**PPL Bell Bend, LLC**  
38 Bomboy Lane, Suite 2  
Berwick, PA 18603  
Tel. 570.802.8102 FAX 570.802.8119  
rrsgarro@ppiweb.com

**BELL BEND NUCLEAR POWER PLANT  
RESPONSE TO RAI No. 47  
BNP-2009-292      Docket No. 52-039**

Response to NRC Request for Additional Information No. 47  
Bell Bend Nuclear Power Plant

**Figure K-2: Bell Bend Link  
Node Analysis Network  
Inset 1**

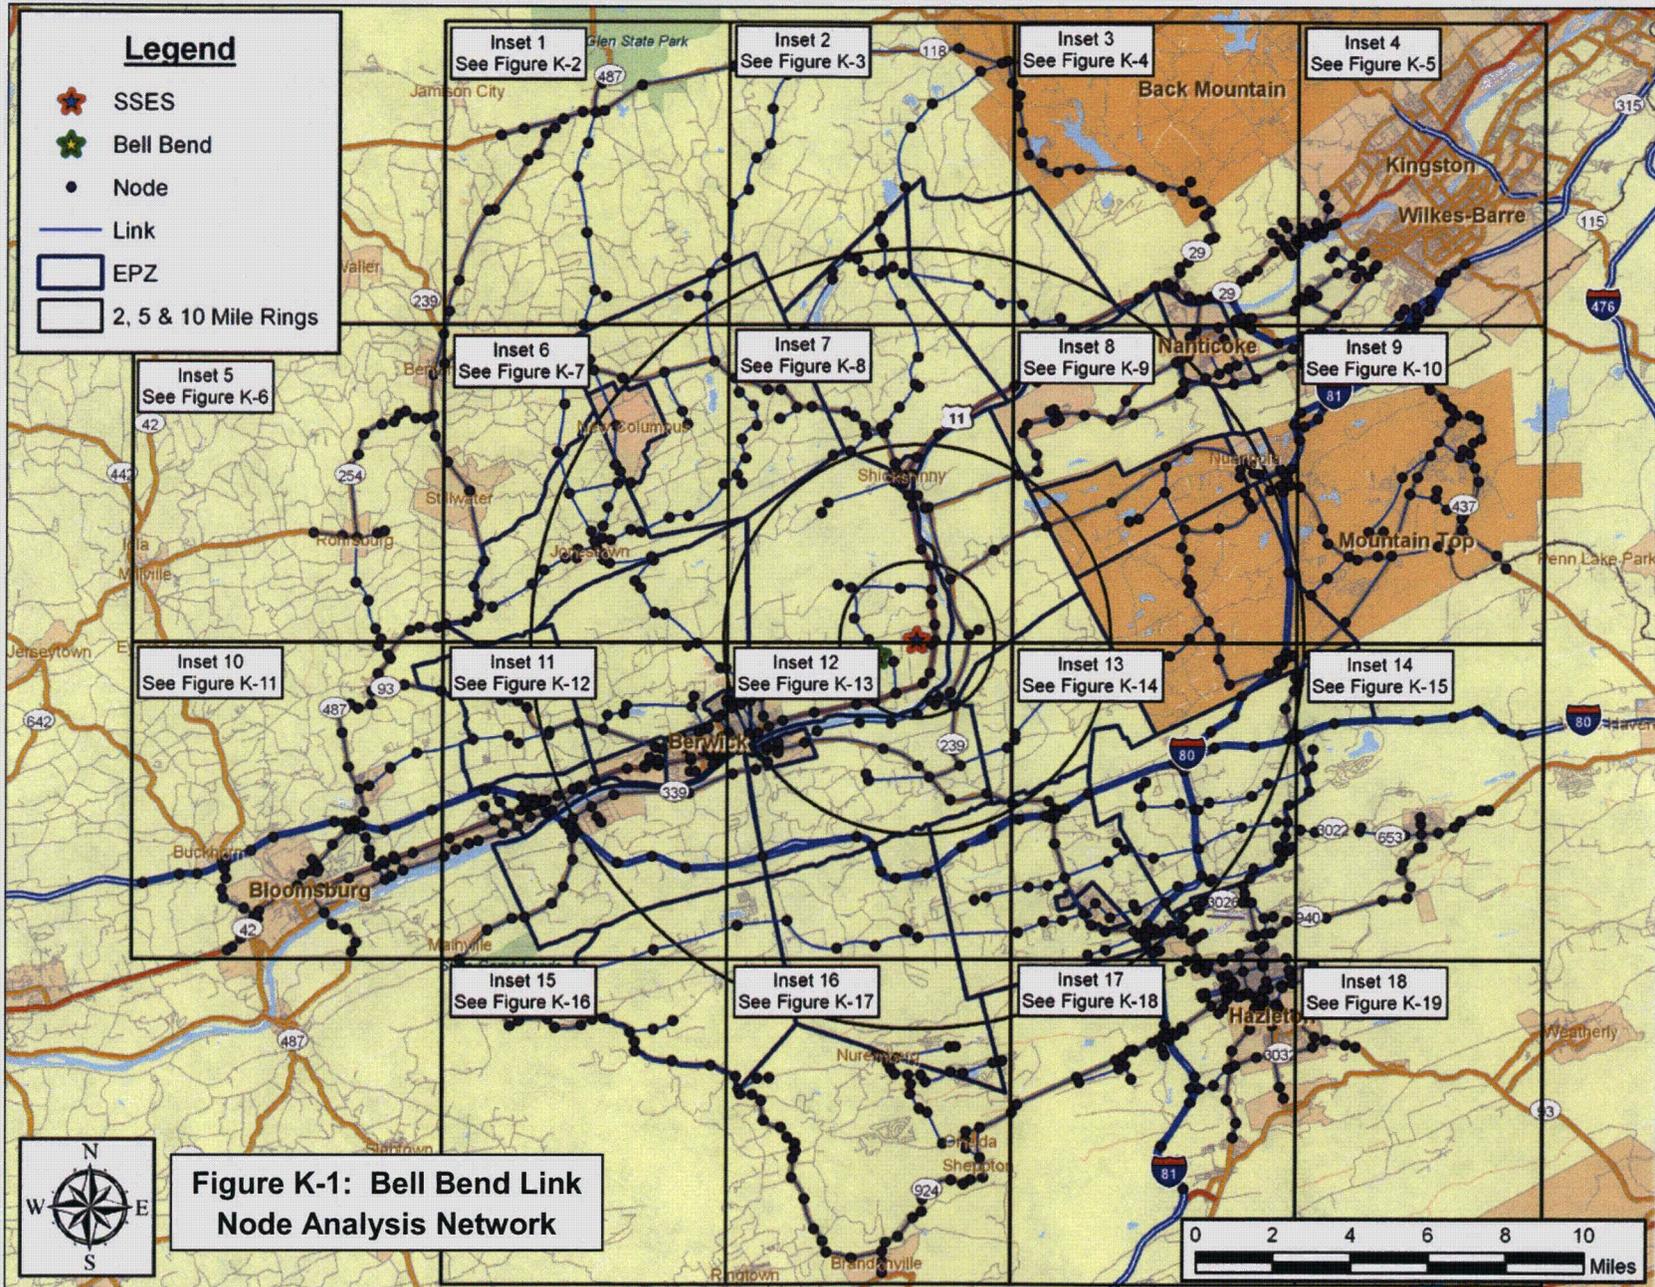
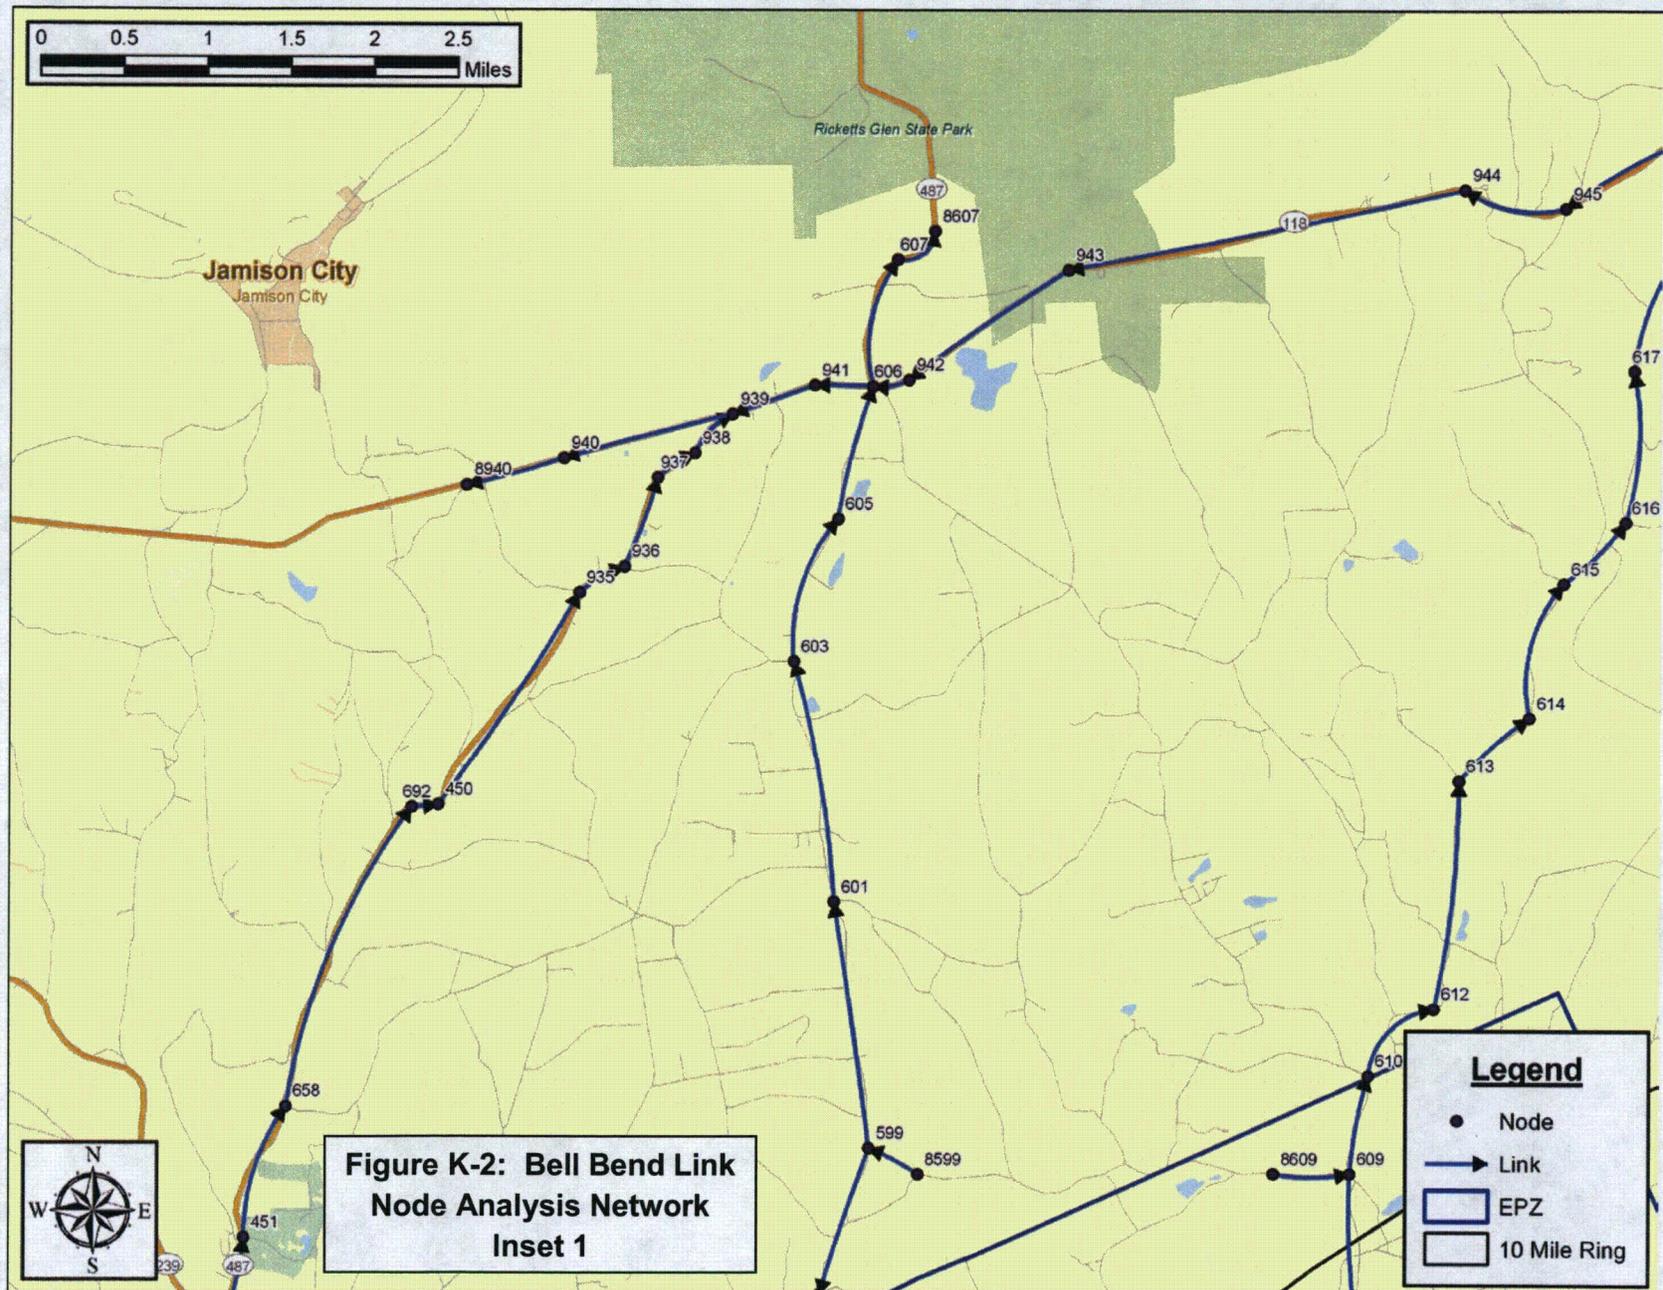
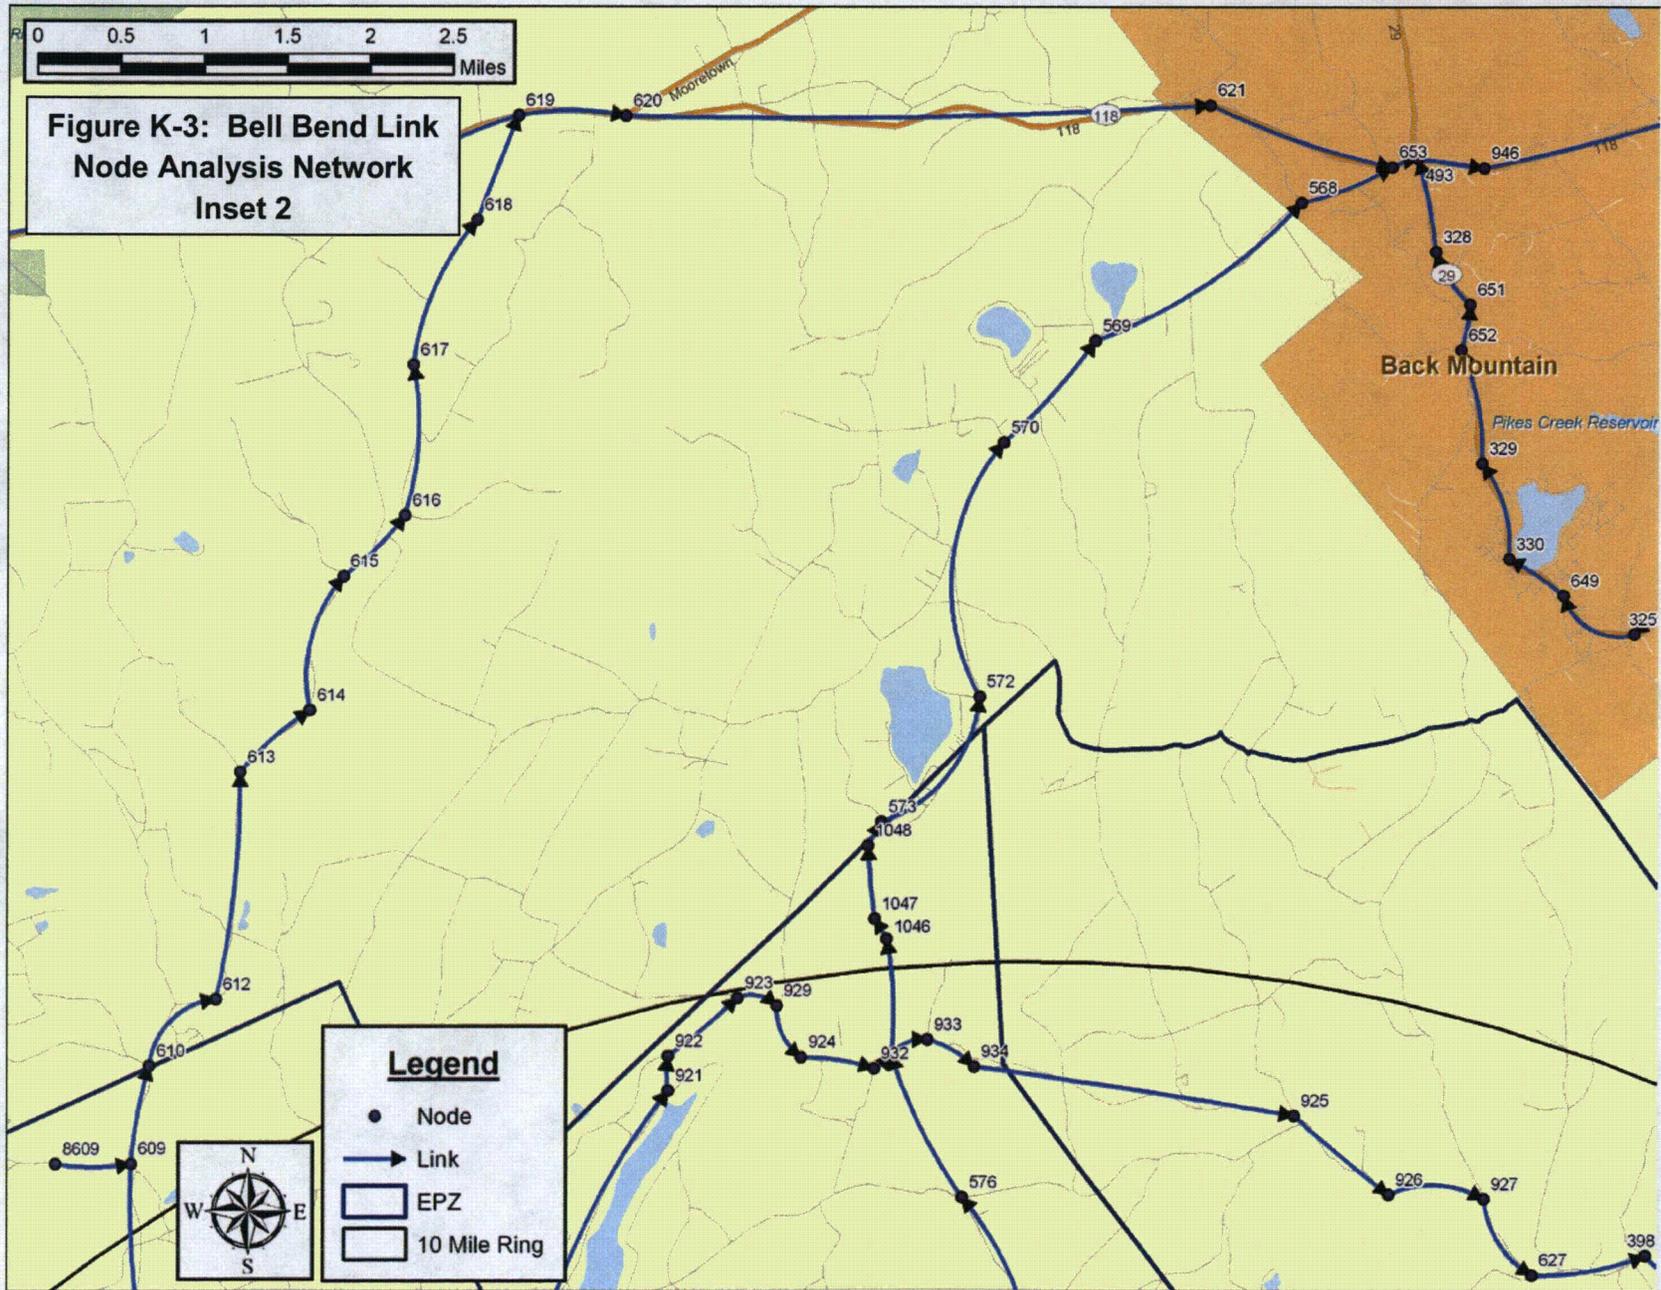
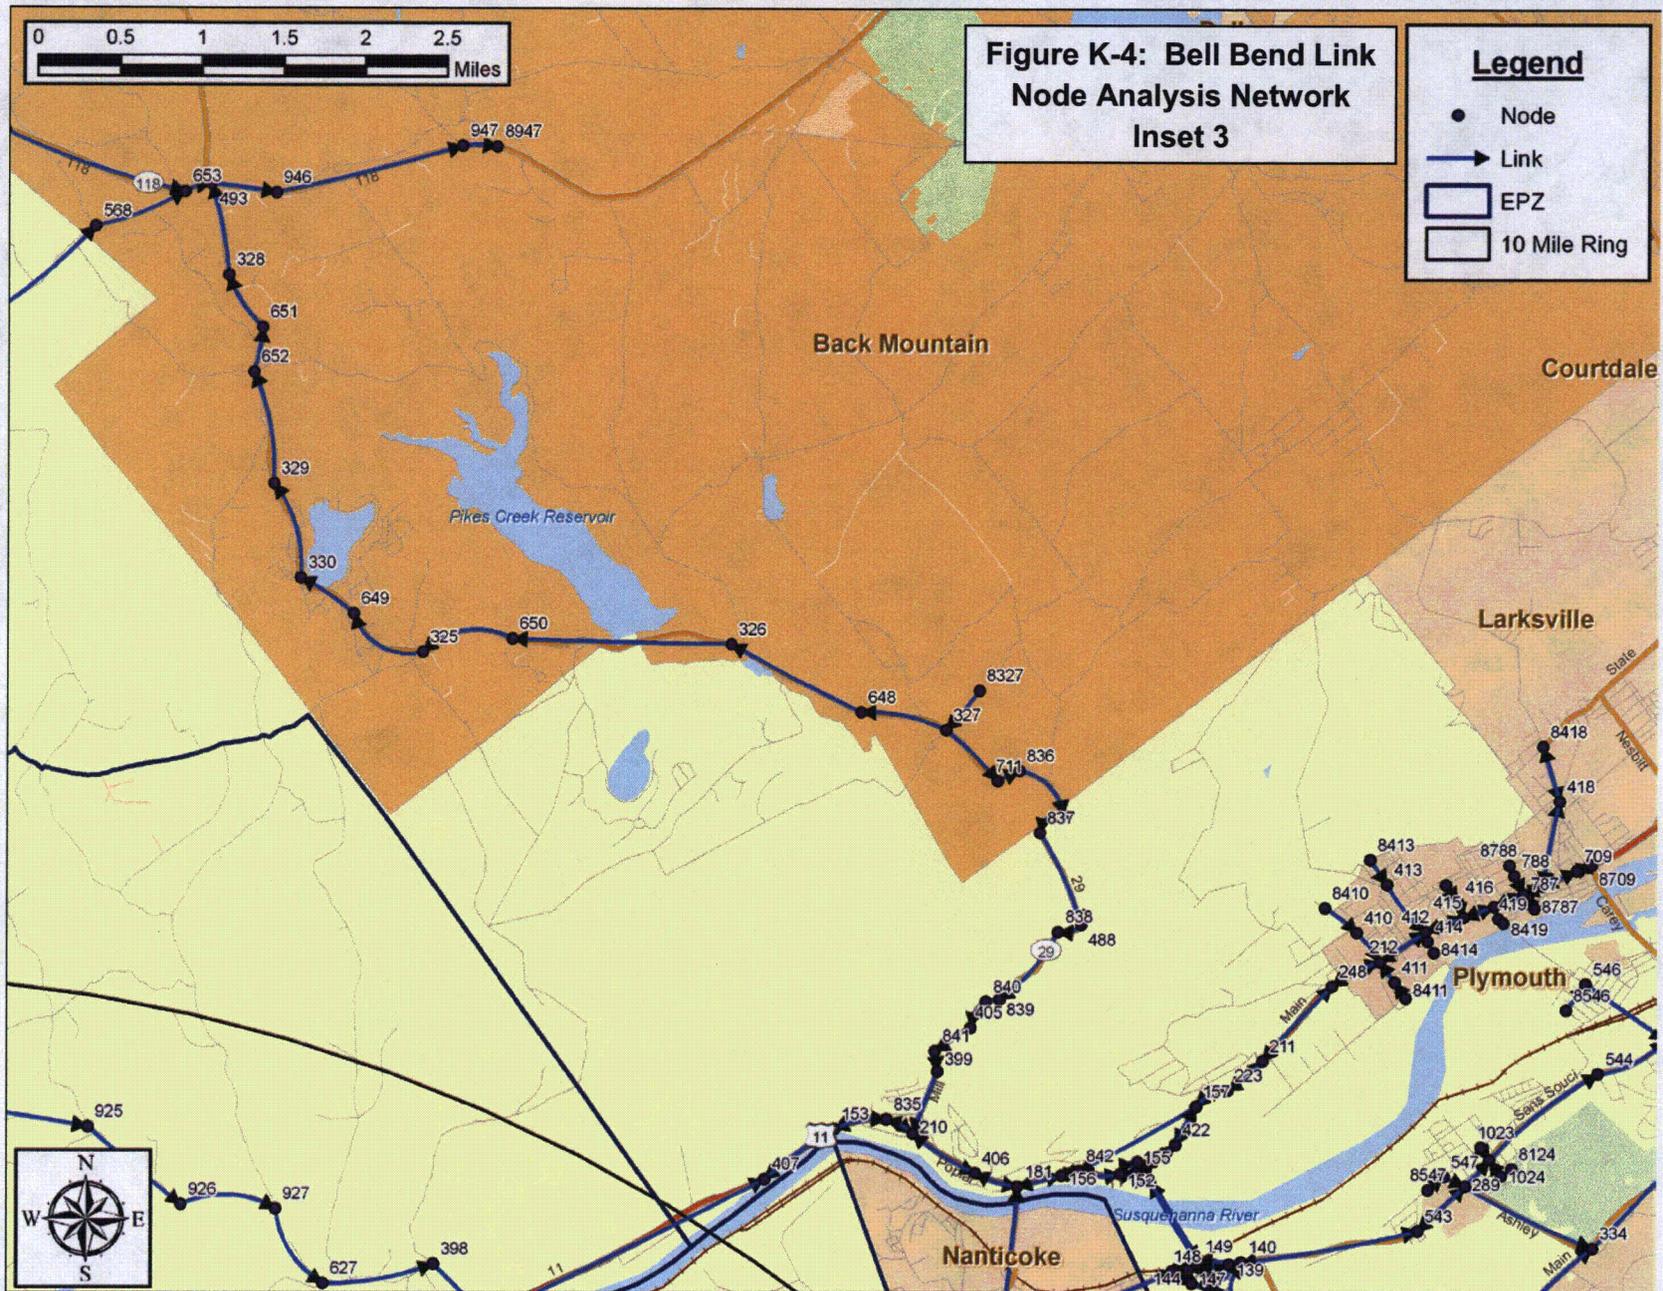
- A. Figure 1-2, "SSES/Bell Bend Link-Node Analysis Network," shows the nodes used in the analysis, but the nodes are not labeled to correspond to Appendix K, "Evacuation Roadway Network Characteristics." Provide a map in a revision to the ETE report that includes legible node numbers that correspond to Appendix K.

Due to the scale of Figure 1-2, the node labels and link directional arrows were removed for clarity. Figure 1-2 will be divided into several figures in Appendix K in a future revision of the ETE report, which will show the directional arrows and annotate the nodes within the link-node analysis network. The reference to Figure 1-2 in Section 1.3 will be revised to reference the newly added figures in Appendix K; these newly added figures are attached to this response.

As discussed in Section 1.3, a computerized link-node analysis network was constructed to model the evacuation roadway network within the study area. Figure K-1 provides an overview of the link-node analysis network. The figure has been divided up into 18 more detailed figures (Figures K-2 through K-19) which show each of the links and nodes in the network.
